# Lakestone Phased Development Agreement (PDA)

LAKE COUNTRY

# Lakestone Phased Development Agreement (PDA) 2<sup>nd</sup> Committee of the Whole

## Retaining Walls

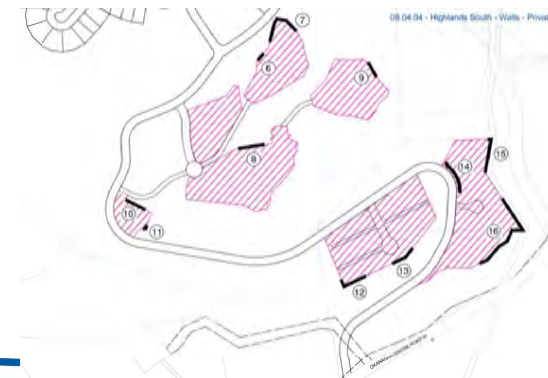
**Concern:** Why are the wall standards set out for Lakestone not being applied District wide?

1. The wall sizes are necessary for Lakestone, so should be left in the PDA.
  2. Concurrently, the DLC is doing a review of its retaining wall policy with the aim to make these rules applicable District wide in areas where applicable / appropriate.
-

- Due to the extreme terrain and elevation changes, a number of private and public retaining walls will need to be constructed.
- The specific Design Guidelines would allow public Developer constructed walls to reach 15 meters in height while most would be less than 10.3 meters in height.
- To reduce workload on staff, private walls could be up to 3 meters without a DVP. A building permit would still be required.
